January 2021 BAR Decision

BAR 21-01-02 (Demolition)

125 Chancellor Street

BAR 21-01-02 (New work and rehab)

3D Laser Scan - **FRONT ELEVATION**

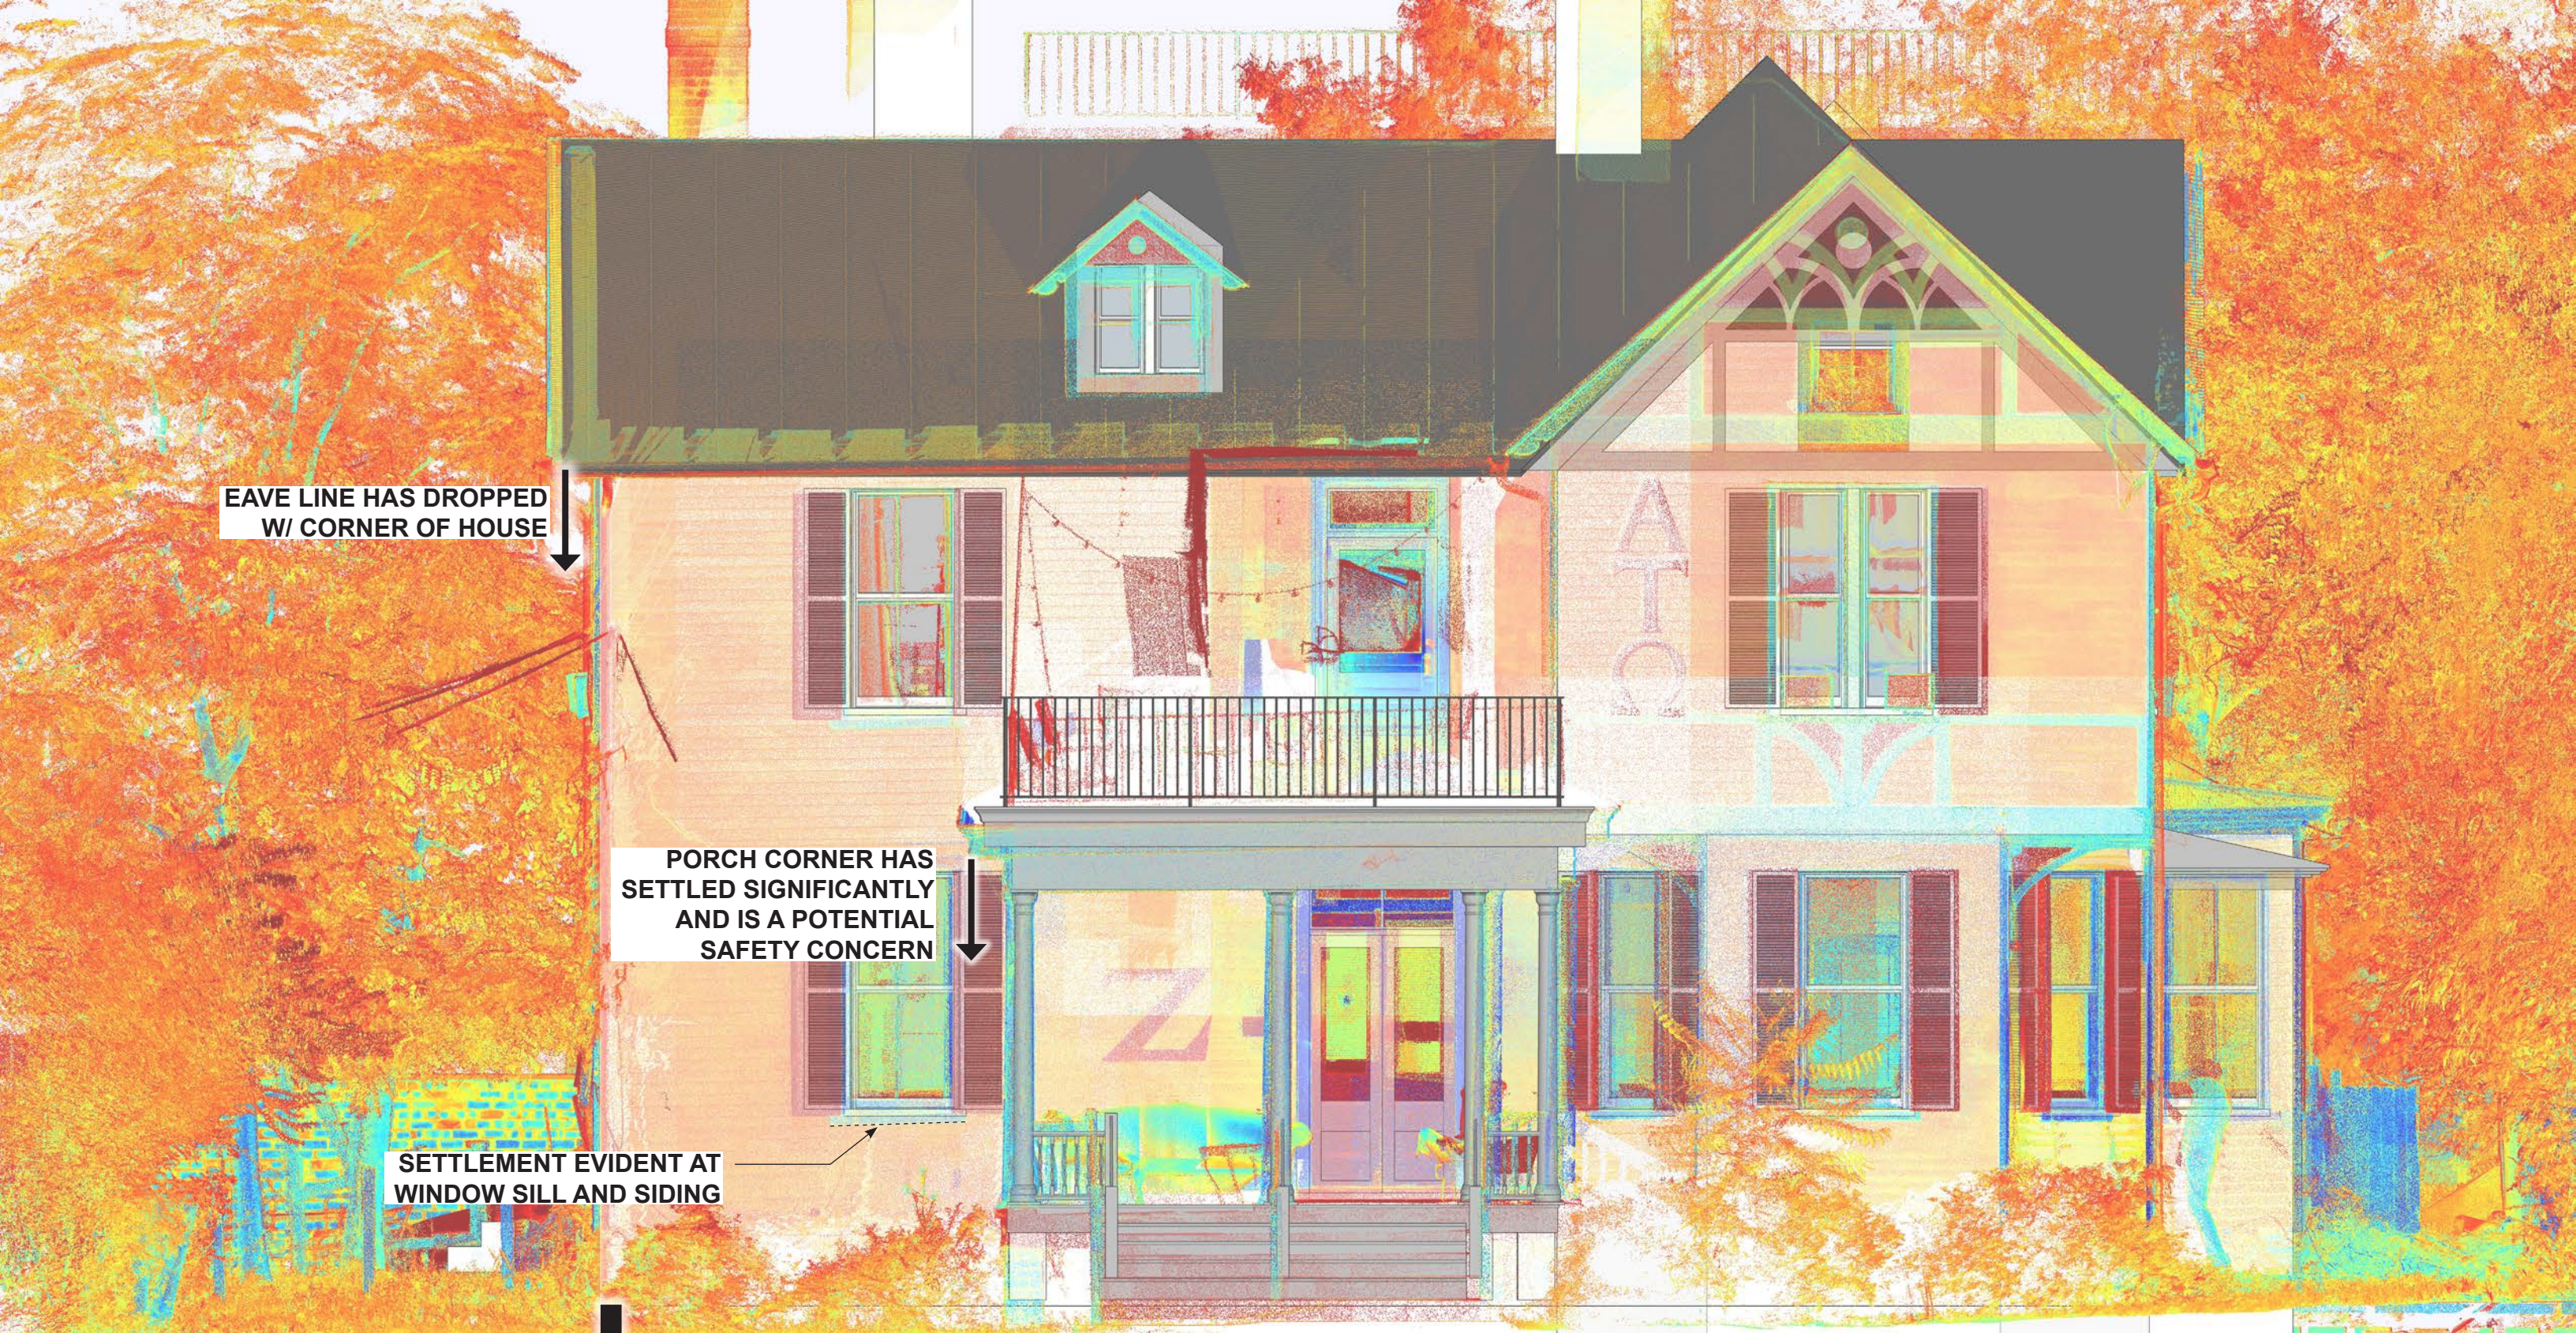
EAVE LINE HAS DROPPED
W/ CORNER OF HOUSE

PORCH CORNER HAS
SETTLED SIGNIFICANTLY
AND IS A POTENTIAL
SAFETY CONCERN

SETTLEMENT EVIDENT AT
WINDOW SILL AND SIDING

CORNER OF HOUSE HAS
SETTLED SIGNIFICANTLY

3D Laser Scan - **SIDE ELEVATION**

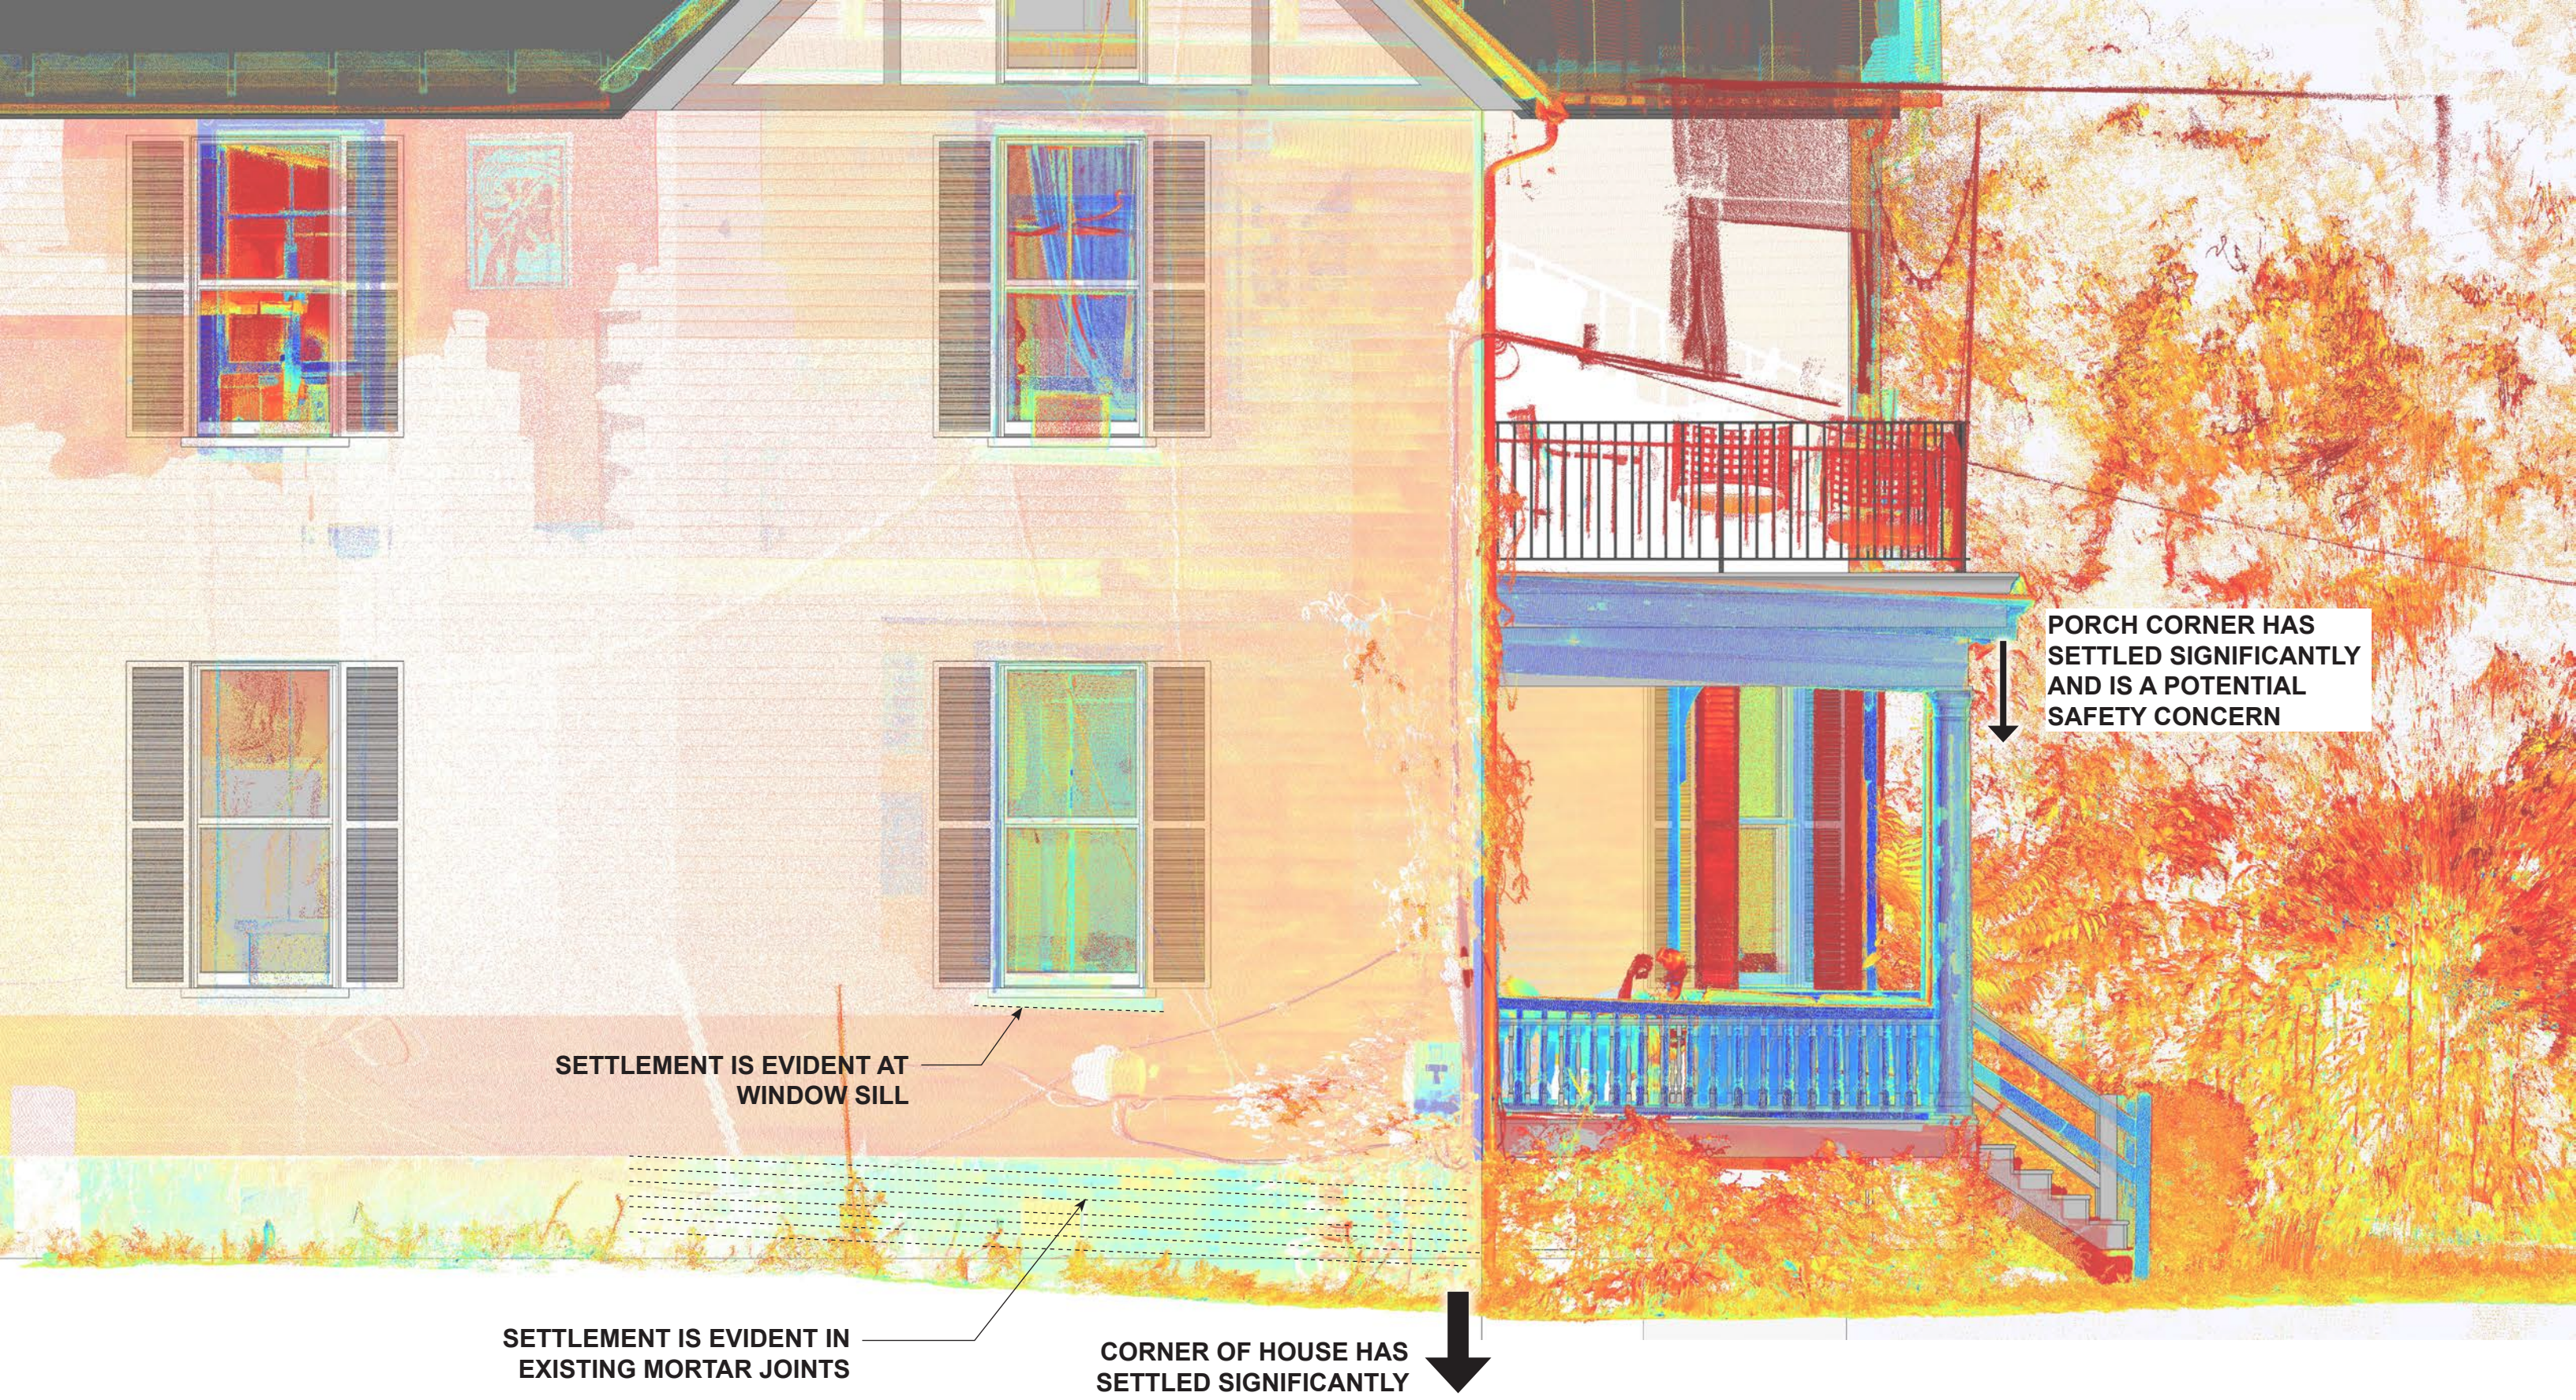
SETTLEMENT IS EVIDENT AT WINDOW SILL

SETTLEMENT IS EVIDENT IN EXISTING MORTAR JOINTS

CORNER OF HOUSE HAS SETTLED SIGNIFICANTLY

PORCH CORNER HAS SETTLED SIGNIFICANTLY AND IS A POTENTIAL SAFETY CONCERN
